Groundwater Transfer Review Summary Form

Transfer/PA # T- 14831

GW Reviewer Stacey Garrison Date Review Completed: 4/23/2026

T-14831 Old Church Rd Estate Homeowner's Association

Injury Analysis

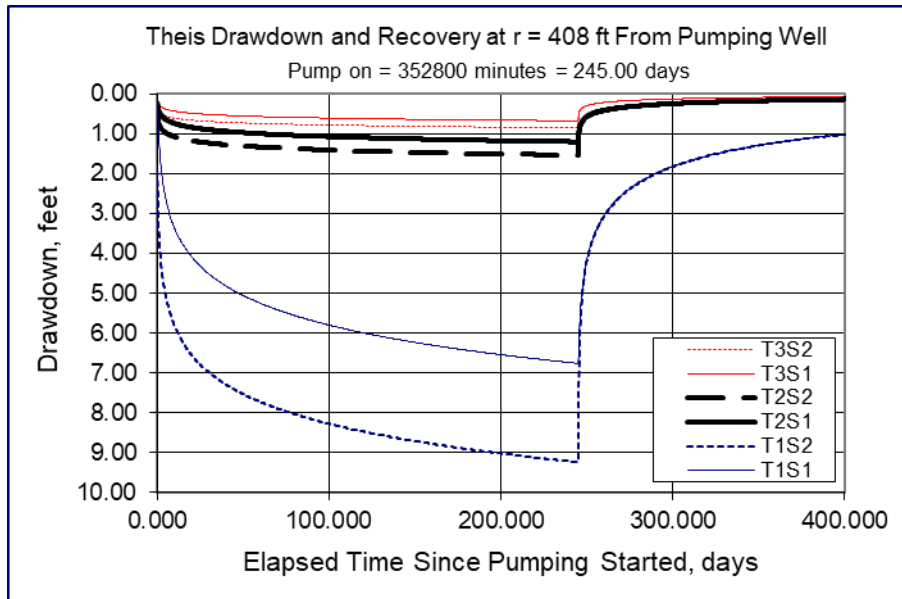
5. a) Will this proposed change, at its maximum allowed rate of use, likely result in an increase in interference with **another ground water right**?
 Yes No Comments: The to-POA/OCRE HOA Well (LINN 57482) is closer to LINN 10492, a POA for Certificate 47521 and Permit G-17073 with priority dates 5/4/1970 and 8/1/1995, respectively.

- b) If yes, would this proposed change, at its maximum allowed rate of use, likely result in another groundwater right not receiving the water to which it is legally entitled?
 Yes No If yes, explain: Water use by the to-POA/OCRE HOA Well (LINN 57482) under the proposed transfer is not likely to result in LINN 10492 not receiving the water to which it is legally entitled.

SWL	2.55 ft bls	LINN 10492, 2003 msmt
Aquifer Bottom	300 ft bls	Gannett & Caldwell 1998
<hr/>		
Available Water Column	297.45 ft	Aquifer bottom-SWL
Pump Height Above Bottom	5 ft	Estimate
NPSHa	5 ft	Estimate
Drawdown	81 ft	Self-drawdown calculated with pump test data and authorized rates under Certificate 47521 and Permit G-17073
<hr/>		
Minimum Water Column	91 ft	Estimated Drawdown + NPSHa + Pump Height
Injury	206 ft	Available Water Column-Minimum Water Column
